**Re: SAD 228 Lot 13 Block 6  
6512 Papagayo NW  
Request for Permanent C.O. - Accepted  
Engineer's Stamp dated: 10-10-18 (D10D003O1)  
Certification dated: 7-2-19**

DRAINAGE CERTIFICATION WITH VERIFICATION BY ENGINEER OF RECORD

GRADING & DRAINAGE PLAN

6512 Papagayo Road, NW

**GRADING AND DRAINAGE PLAN**  
**LOT 1, BLOCK 8, UNIT 18, VCS**  
**ADDRESS: 6512 Papagayo Rd NW**

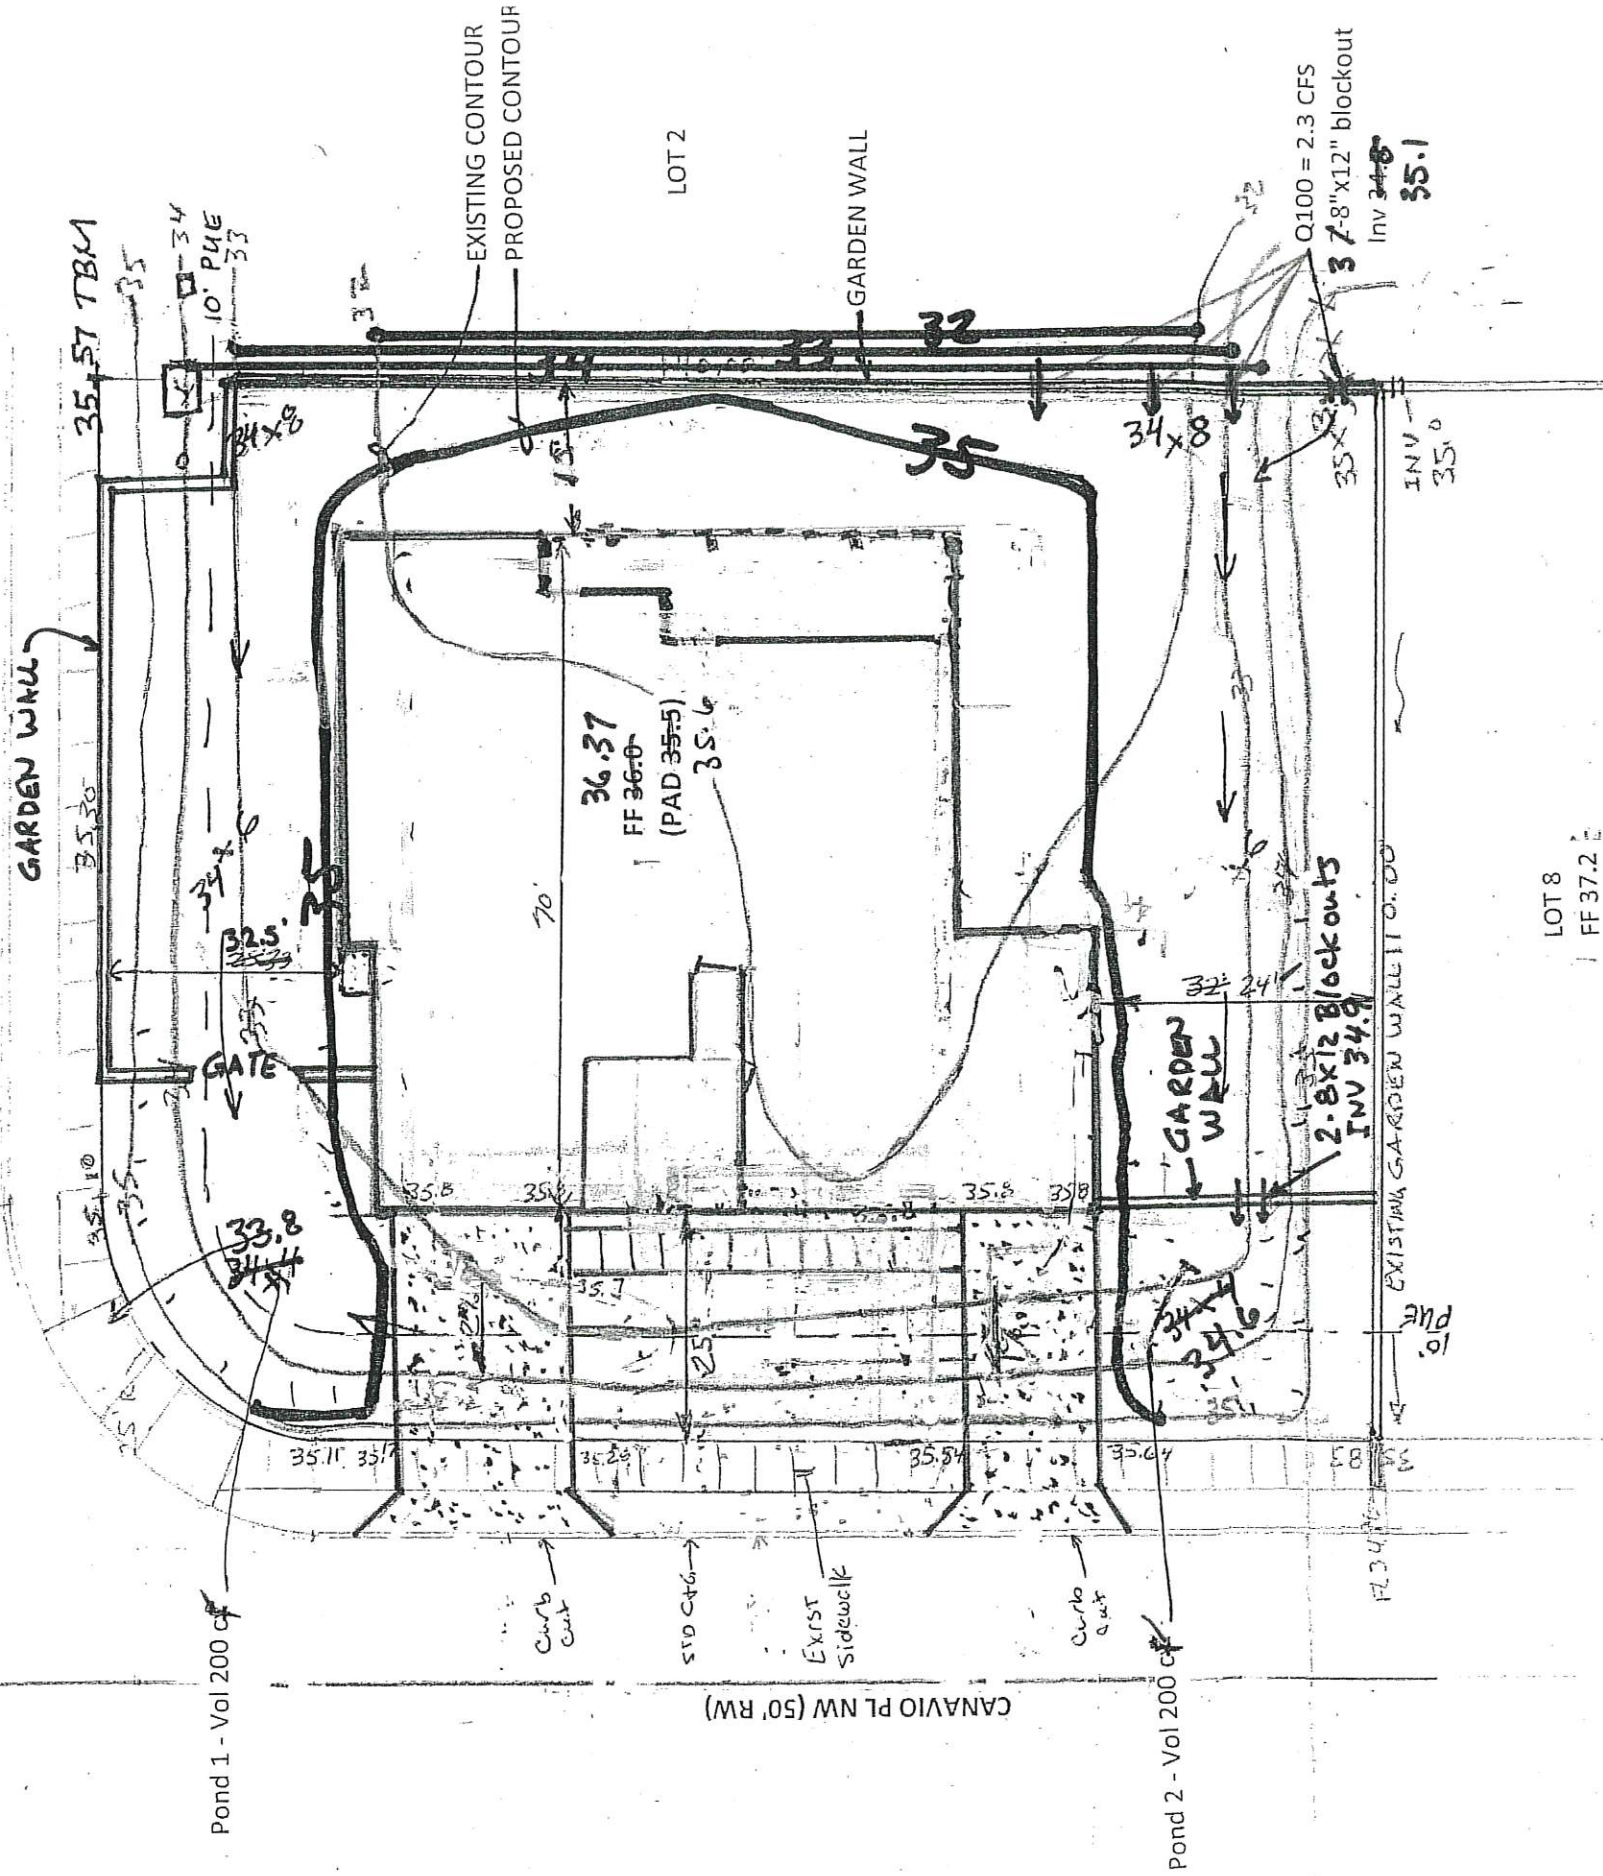
Based upon the information provided in your submittal received 1/17/17, the above referenced Grading and Drainage plan dated 1/17/17 cannot be approved for Grading Permit until the following comments are addressed:

- Provide a note stating that future garden walls require a separate permit and this plan should be used for their placement.
- Also state that future garden walls require an opening 3" above grade in the SW corner.
- Provide a statement that a pad certification is required before a building permit is given.

Note:  
1. Future garden walls require a separate permit and this plan should be used for their placement.  
2. Future garden walls require an opening 3" above grade in the SW corner.  
3. A pad certification is required before a building permit is given.
